Proposal for Supplements to UN Regulation No. 48

This document is a revised proposal to permit the use of very small logos on signalling lamps. It is based on ECE/TRANS/WP.29/GRE/2020/5/Rev.2 and GRE informal document GRE-85-26 which were submitted to the eighty-fifth session of the Working Party on Lighting and Light-Signalling (GRE). The modifications to are shown in bold.

A. Proposal for a Supplement to the 06, 07 and 08 series of amendments to UN Regulation No. 48

Here below some examples:

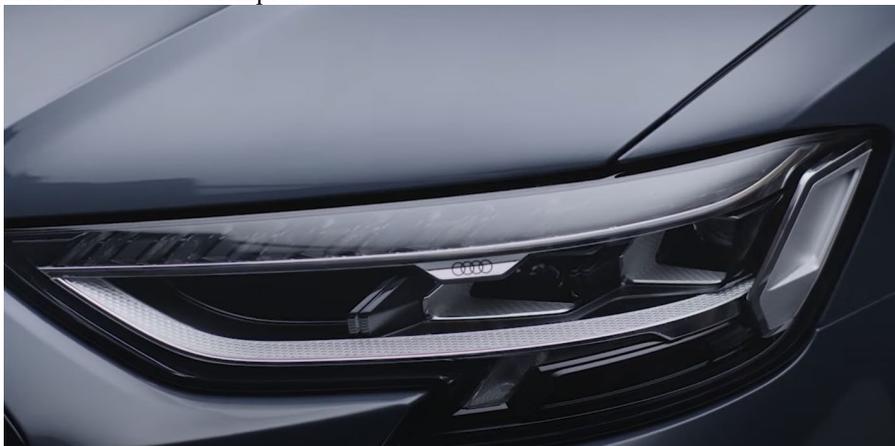
4. The evaluation introduced in GRE-85-16 implies that small structures cannot be identified by the human eye in relevant distances if their size does not exceed 100 cm² and their structures are composed of elements of less than 10 mm size. We believe that an exemption for extremely small trademarks is possible because they cannot be identified as logos and therefore cannot have a negative influence on traffic safety.

5. Our approach is to exclude logos of less than 5 cm² from the requirements. This size is so small that the trademarks cannot act as representative signs because even within close vicinity to the vehicle they are not visible.
